RE: Submittal of Value Engineering Study Report  
Project Task Order No. 7 – Contract TOOESV060196  
Project Jennings Mill Parkway  
**Project No.** STP-F001-00(098) – P.I. Number: 0001098  
**County** Oconee

# Value Engineering Study Report

## Project Jennings Mill Parkway SR 316 to Epps Bridge Road State Aid Project

P.I. No. 0001098  
*STP-F001-00(098)*

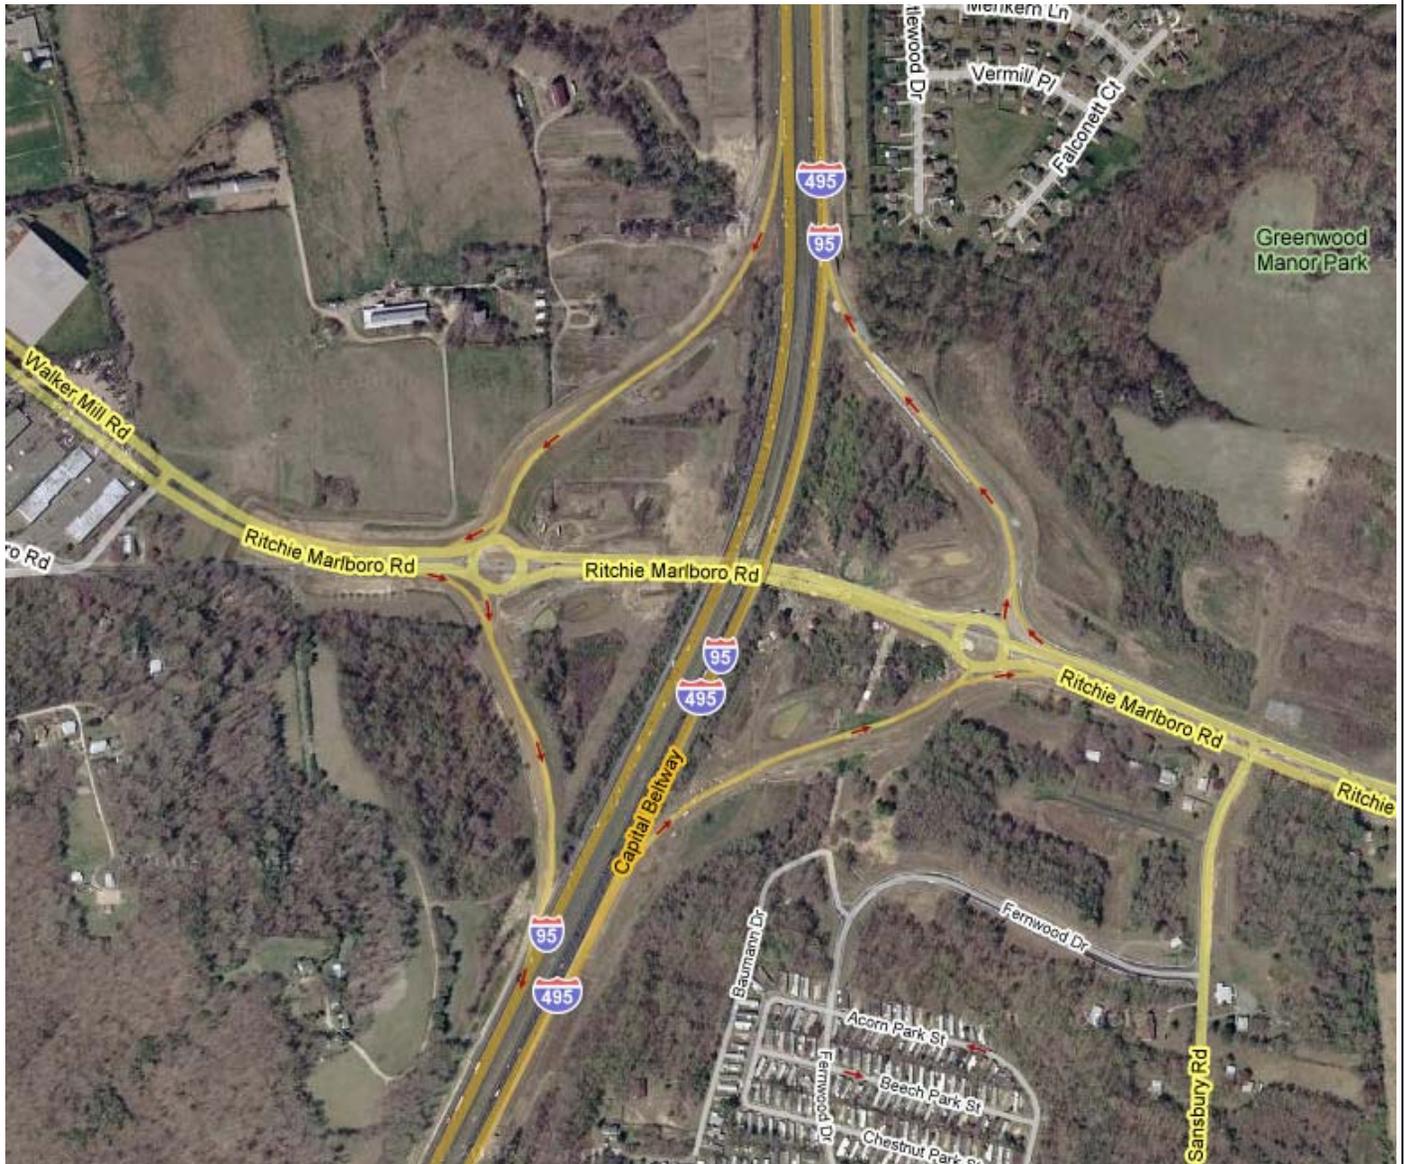
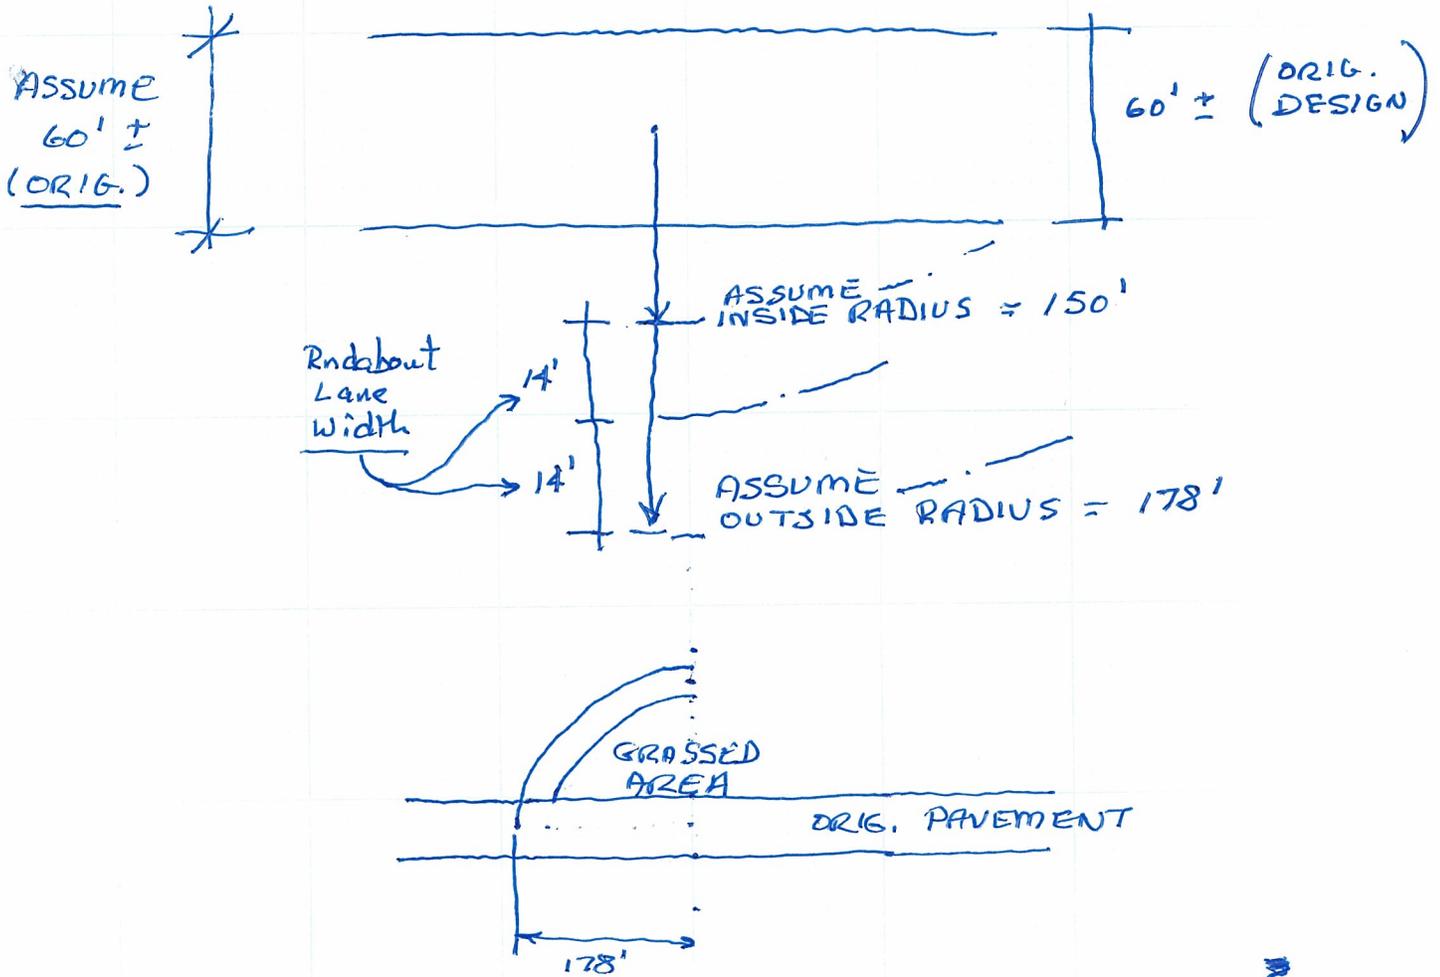
Some would argue that the roundabout is an unexpected encounter for many motorists and can cause orientation problems. However, these roundabouts are now being employed in many states, very successfully. Attached is a print-out from MAPQUEST that includes the air photo of a recently installed roundabout in a high volume area serving MD State Highway 2 connections off the Capital Beltway (I-495/I-95). This roundabout works well. Its use was embraced the Maryland State Highway Administration and FHWA.

CALC PAVEMENT ADDITION TO BUILD ROUNDABOUTS:
